Re: Site Specific Investigation  
Upland Heights Block 2 Lot 1  
Technical Review

This letter serves to present the findings of our technical review of the site specific investigation prepared by Trihydro Corporation (Trihydro) for the City of Laramie for the City owned Upland Heights Block 2 Lot 1 parcel of land located within the Casper Aquifer Protection Area. Our review comments will be presented to address the adequacy of this site specific investigation in fulfilling the requirements of the City of Laramie's Unified Development Code, subsection 15.08.040.A.8.

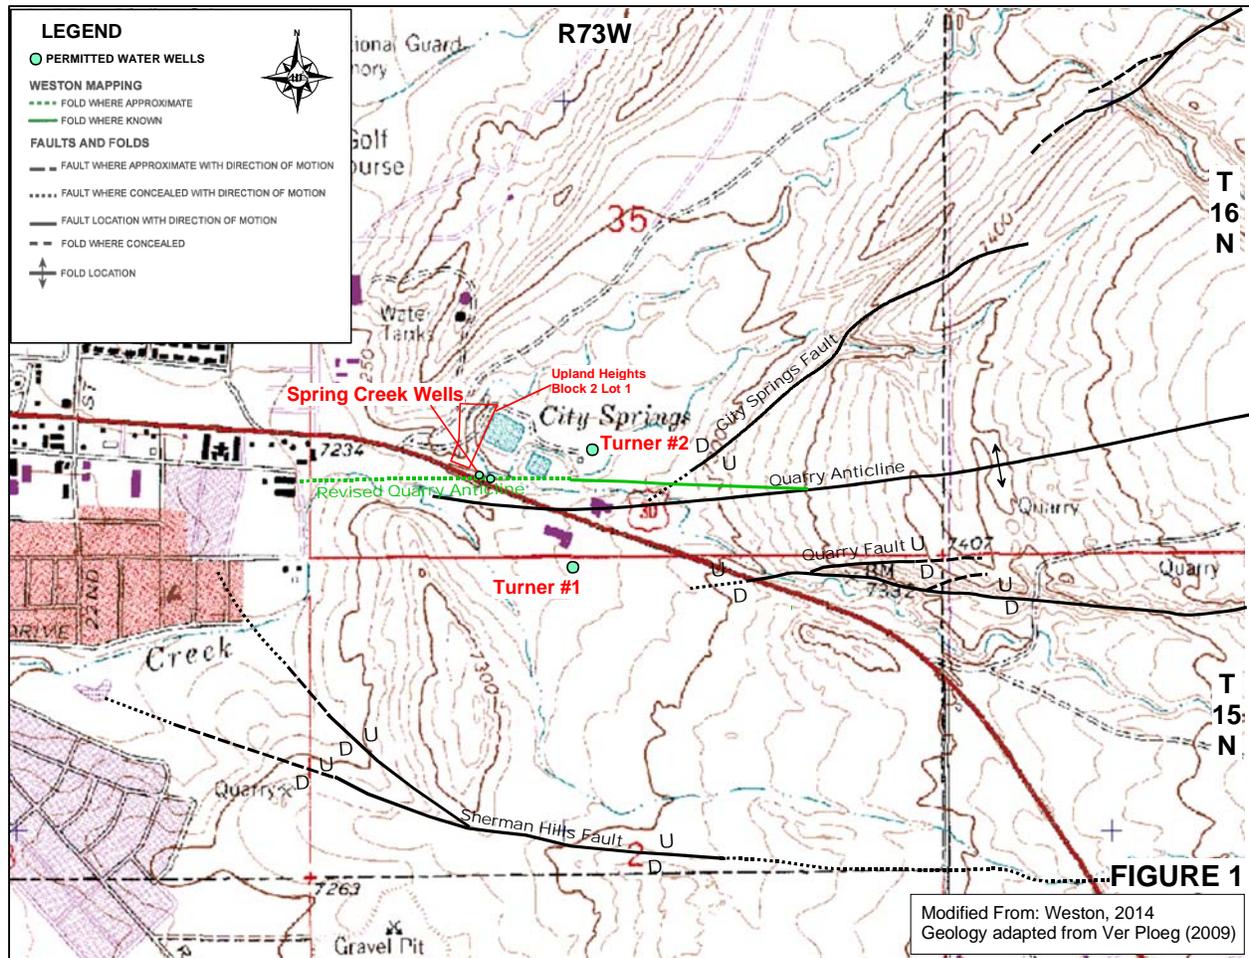
One item that was researched and discussed in later sections of Trihydro's SSI, but not listed in this section of their report, were the State Engineer's Office completion records for the wells in the subject property area. A review of the statement of completion records for the two Wyoming State Highway Department wells (Spring Creek Well Nos. 1 and 2) located immediately to the south of the study site reveals that "fractured zones" were encountered at depths below approximately 20 feet. The reference to fracture zones in the nearby wells is evidence that

conduit flow could be present in the area of the Upland Heights Block 2 Lot 1 parcel. The locations of the Spring Creek wells are shown in the figure below.

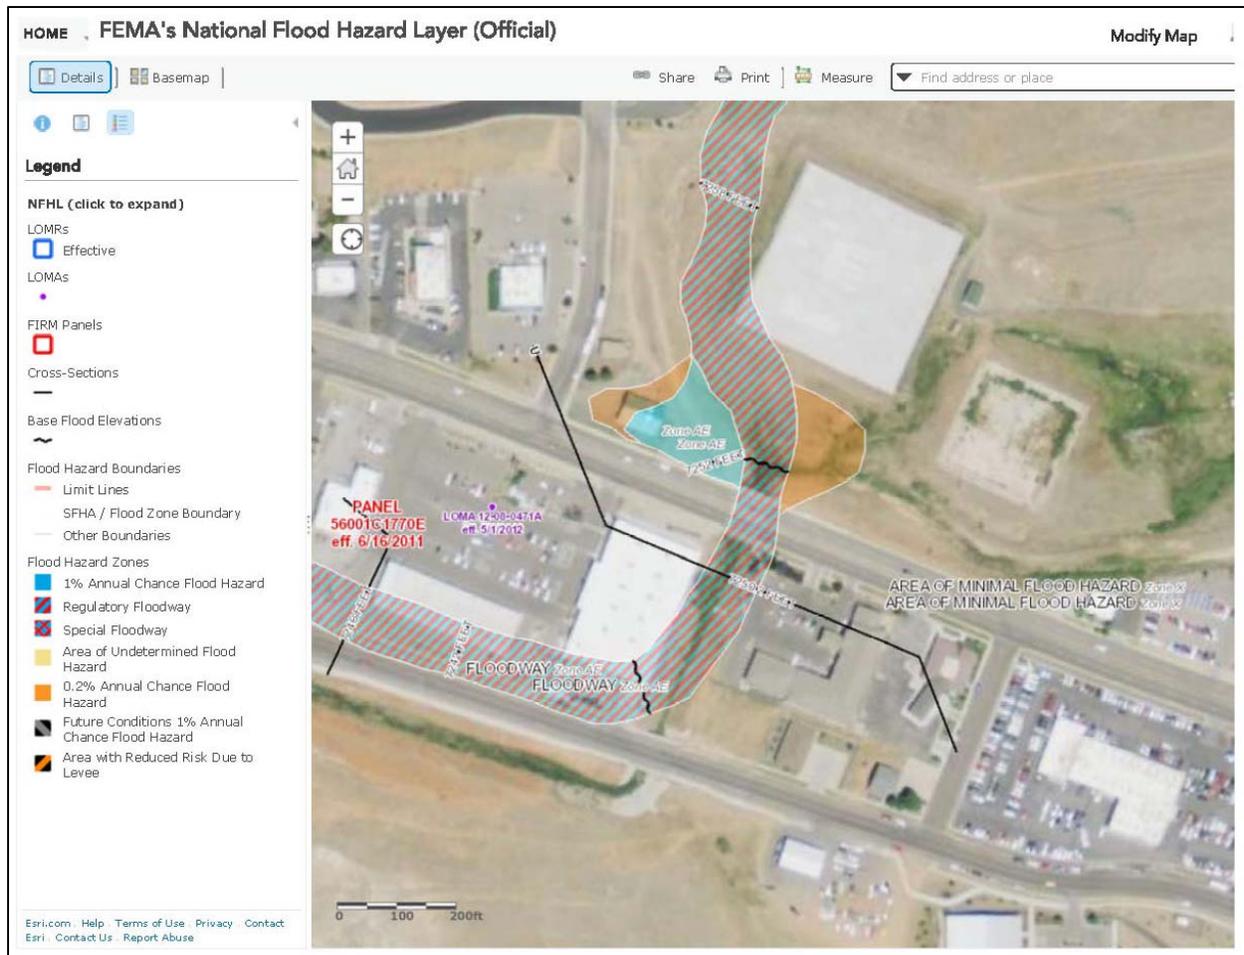
As discussed under the 15.08.040.A.8(d)(i) section, two vulnerable features, Quarry anticline and an unnamed ephemeral drainage, were identified in the Upland Heights Block 2 Lot 1 area. However, only the unnamed drainage is located within the 100 foot setback distance. The SSI prepared by Trihydro presents a map (Figure 1) which identifies the location of only the Quarry anticline. The location of the other vulnerable feature, unnamed drainage, is discussed in the text of the SSI report but is not called out in this figure. The drainage is shown more clearly in Figure 2 of the SSI report, but is again not labeled. No evidence of fracturing was noted in the unnamed drainage and no spring flow is present. During the design and construction of the Wister Drive Pump Station, groundwater at the pump station site was encountered at a depth of 13 feet below ground level (approximate elevation of 7,242 feet).

The Trihydro SSI report accurately identifies the nearby wells as: 1) the City of Laramie Turner #2 well (U.W. 55508); 2) WYDOT's Spring Creek #1 well (U.W. 69160); and 3) WYDOT's Spring Creek #2 well (U.W. 69161). Only the location of the Turner #2 well is shown on Figure 1 even though the SSI report text indicates that all three of these wells have been shown on this figure. The Spring Creek wells are located just to the east of the Upland Heights Block 2 Lot 1 parcel on the east and west side of the Grand Avenue bridge that crosses Spring Creek (northeast and northwest abutments). The locations of these nearby wells have been shown in the figure on page 3 of this letter report.
